Bid Number FY22-08

WINDMILL PARK SOFTBALL FIELD #1 FENCE REPLACEMENT

ADDENDUM 2

UPDATE TO SPECIFICATIONS

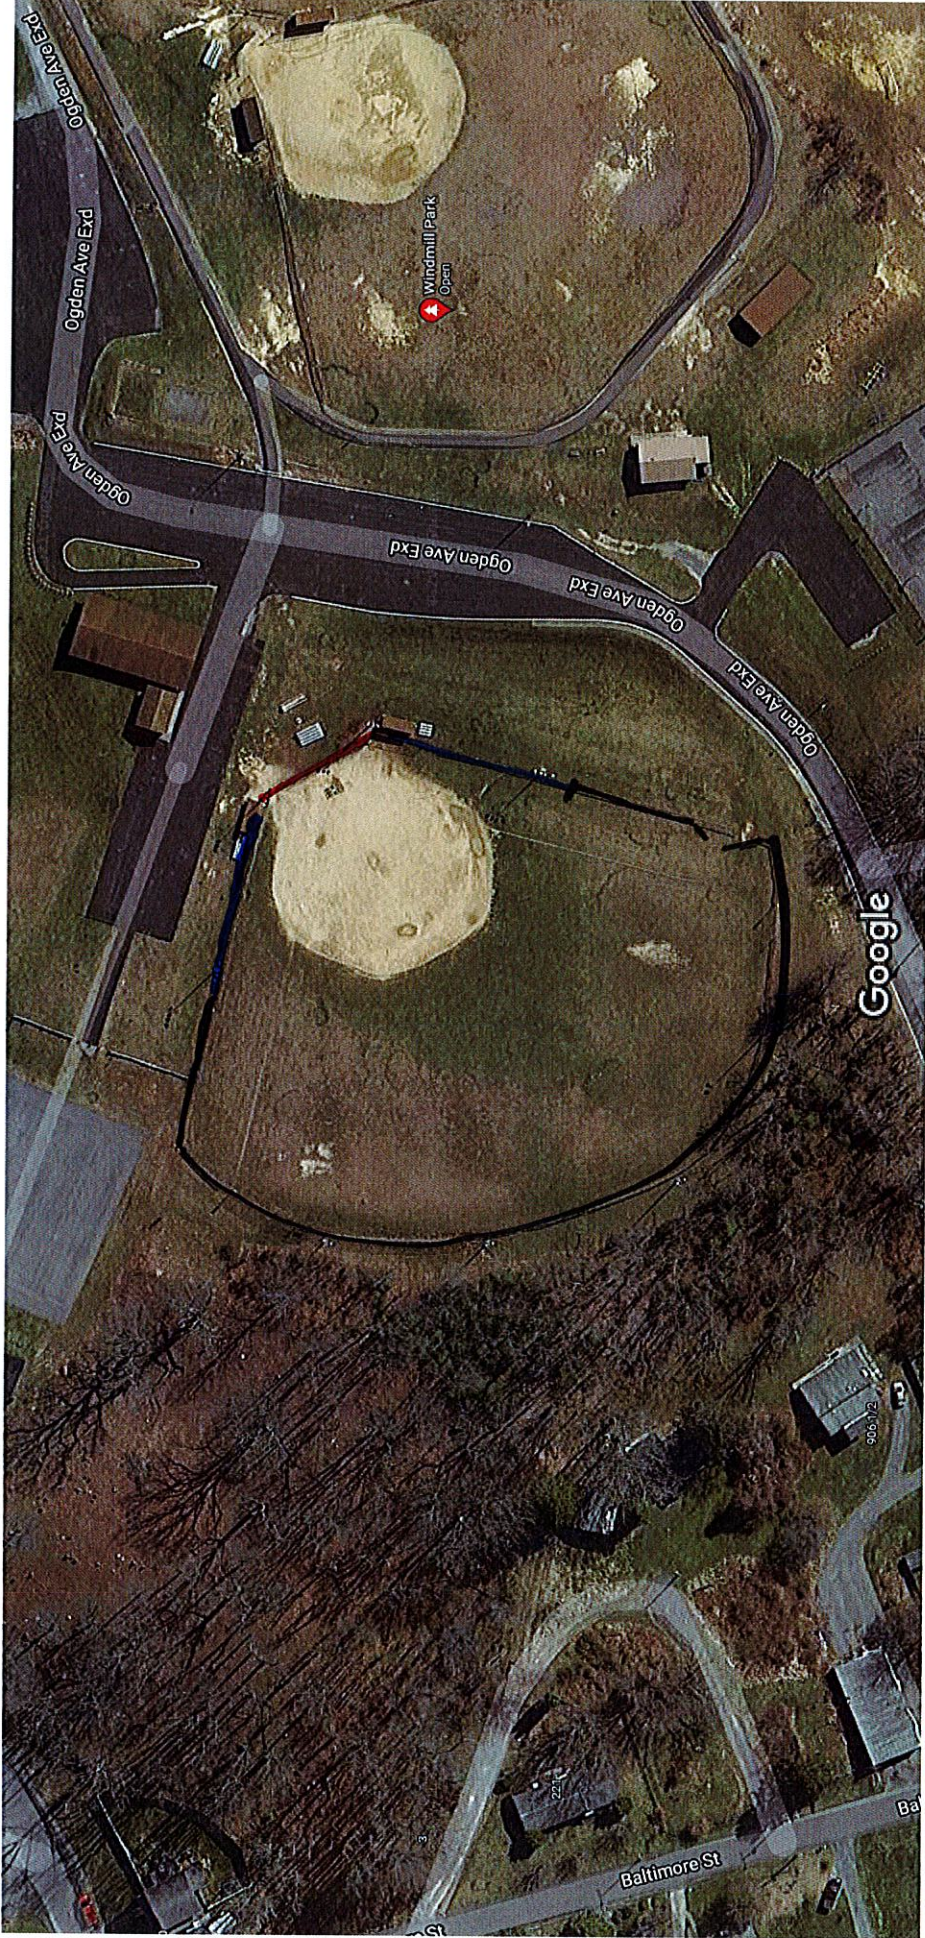
FENCE BEHIND HOME PLATE QUOTE FOR 14' HIGH

- 9 Gauge Fence Chain Link
- COMMERCIAL GRADE
- SS40 Posts
- SS40 DD Gate 12' in left field side.
- Fence behind home plate is to be 14' high- 35' long.
- Fence along 1st and 3rd plate from home plate is to be 10' high for a distance of 60' each side.
- Fence in all other areas is to be 4' high.

FENCE BEHIND HOME PLATE TO BE 14' HIGH AND 35' LONG

FENCE ALONG FIRST BASE AND THIRD BASE TO BE 10' HIGH AND 60' LONG ON EACH SIDE

FENCE IN OUTFIELD TO BE 4' HIGH 12' GATE IN LEFT FIELD SECTION
